WASHINGTON STATE DEPARTMENT OF TRANSPORTATION

Flared Energy Absorbing Terminal

FLEAT TL-2
1'-8 to 2'-8" Offset

Drawing Name: FLT-W-TL2-US-R3

Foundation Tube Options For Posts 1 & 2

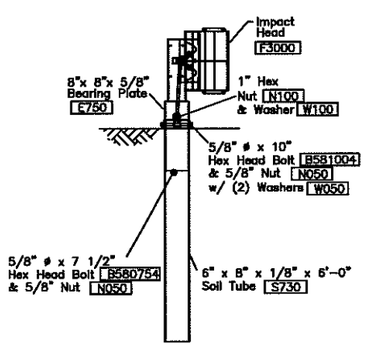
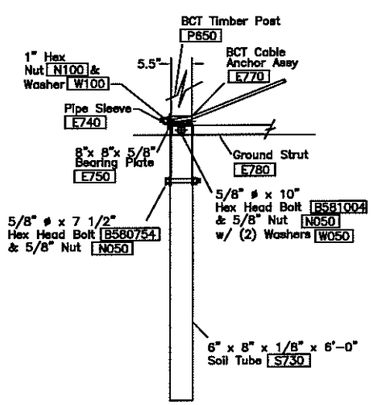
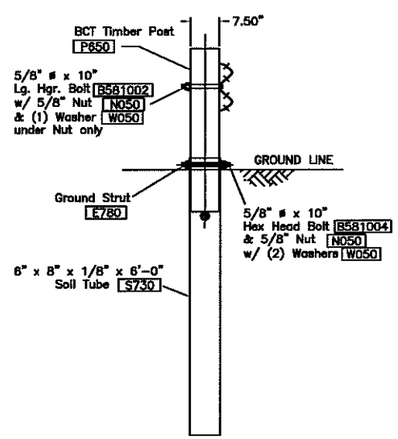
☆ E735

ITEM #	QTY	BILL OF MATERIALS
F3000	1	IMPACT HEAD
F1303	1	W-BEAM GUARDRAIL END SECTION, 12 GA.
G1203	1	W-BEAM GUARDRAIL CENTER SEC., 12 GA.
~~S730~~	2	*FOUNDATION SOIL TUBE, 6" x 8" x 6'-0"
E740	1	PIPE SLEEVE
E750	1	BEARING PLATE, 8" x 8" x 5/8"
S760	1	CABLE ANCHOR BOX
E770	1	BCT CABLE ANCHOR ASSEMBLY
E780	1	GROUND STRUT
P650	2	5.5" x 7.5" x 45" WOOD POSTS
P671	3	6" x 8" x 6'-0" WOOD CRT POST
P675	3	6" x 8" x 14" TIMBER BLOCKOUT
		HARDWARE
B580122	16	5/8" Dia. x 1 1/4" SPLICE BOLT
B580754	2	5/8" Dia. x 7 1/2" HEX BOLT
B581004	2	5/8" Dia. x 10" HEX BOLT
B581002	1	5/8" Dia. x 10" H.G.R. BOLT (Post 2 Only)
B581802	3	5/8" Dia. x 18" H.G.R. BOLT (Posts 3 thru 5)
N050	24	5/8" Dia. H.G.R. NUT (SPLICE 16, SOIL TUBES 2, STRUT 2, POST 2, 1; POST 3 thru 5, 3.)
W050	8	H.G.R. WASHER
N100	2	1" ANCHOR CABLE HEX NUT
W100	2	1" ANCHOR CABLE WASHER
E350	2	3/8" x 3" LAG SCREW
SB58A	8	CABLE ANCHOR BOX SHOULDER BOLTS
N055A	8	1/2" A325 STRUCTURAL NUTS

* 4'-6" Foundation Tube to be installed unless approved by the Engineer

*6'-0" Split Foundation Tubes S730
*6'-0" Solid Foundation Tubes E731
*5'-0" Foundation Tubes S735 W/Soil Plates SP600
*4'-6" Foundation Tubes E735 W/Soil Plates SP600
